# Variation to the Marine Licence 06820 (dated 28 June 2019)

A 2021 wind tunnel specialist's computational analysis predicted a previously undetected vortex shedding response at high wind speeds in the 2nd bending mode (mode 7) that is inherent to the original bridge. Consequently structural damage under Mode 7 could start to occur for a steady windspeed above 33m/s in the north-easterly direction.

#### **Variation Reference Number 1**

#### Tuned Mass Dampers at the ¼ points of the mid-span

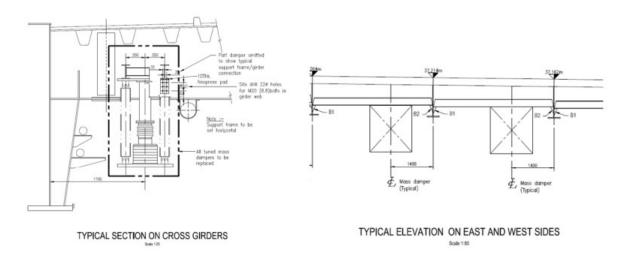
Tuned Mass Dampers (TMDs) are units mounted under the bridge structure to reduce the amplitude of mechanical vibrations on the bridge caused by wind and vehicular traffic. There are four existing TMDs located in the main span of the A9 1350 Kessock bridge. These are located at mid-span on Span 8.

Additional Tuned Mass Dampers would be installed 60 metres and 180 metres north of Pier 8. Refer to drawing 19/NW/1203/001. The proposed TMDs would be similar to those fitted to the bridge deck in 2016. TMD's fitted adjacent to both the east and west main girders at each location.

The proposed TMDs would be tuned to a frequency of 0.783Hz to target the bridge's natural frequency in mode 7. The TMDs would be connected to a support frame that spans the cross girders.

#### **Under-deck Baffle Plates**

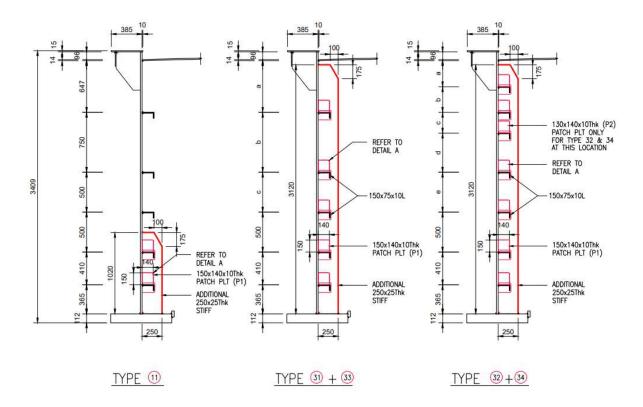
The proposed under-deck baffle plates would be designed such that the modification of the deck geometry and wind flow on the deck would provide passive stability against both the VIO and flutter response.

Concept 1 above would be the preferred solution as the baffle plates are concealed under the bridge deck.

Baffle plates would not be needed along the whole of the bridge and are likely to be installed locally on Span 8 or on Spans 7, 8 and 9.
